Access Compliance Report

Public Rights-of-Way

(Curb Ramps)

Intersection ID: 10035606	Main Street: REAVENCREST_PARK_DR	Cross Street: N/A	Location: NW
ADA ID: 20E6BFF099BD	Ramp Type: PerpDiag	Initial Pass/Fail: Fail	Overall Compliance: No
		Severity Score: 17.5

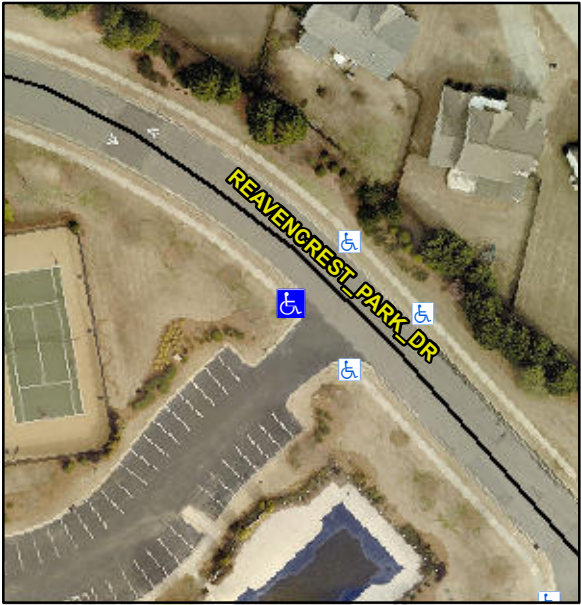
Codes/Mitigation Info/Possible Solution			Field Measurements/Component Compliance			
	Possible Solutions:		Compliance	Description	Data	
	Remove & Replace Curb Ramp With Two New Directional Ramps or Equivalent.		N/A	Ramp Length (in)	100.0	Yes
			No	Ramp Width (in)	32.0	Yes
			N/A	Flare Type LT	N/A	N/A
			N/A	Flare Slope LT (%)	N/A	N/A
			N/A	Flare Traversable LT?	N/A	N/A
			N/A	Landing Length (in)	N/A	N/A
			N/A	Landing Width (in)	N/A	N/A
			N/A	Landing Slope (%)	N/A	N/A
			N/A	Landing X Slope (%)	N/A	N/A
			N/A	Landing Curb? (Y/N)	N/A	N/A
			N/A	Shared Landing?	N/A	
			N/A	Gutter Ponding?	N/A	N/A
			N/A	Gutter Lip Ht (in)	N/A	N/A
			N/A	Painted X Walk1?	No	N/A
				X Walk 1 Direction	To SE	
			N/A	X Walk 1 Width (in)	N/A	N/A
				X Walk 1 Slope (%)	0.3	
				X Walk 1 X Slope (%)	2.1	
			N/A	Ramp inside XWalk1?	N/A	N/A
Surveyor Notes: N/A PROW/ADA: Not Found, R304.5.1						
				Ramp Slope (%)	6.7	
				Ramp XSlope (%)	1.3
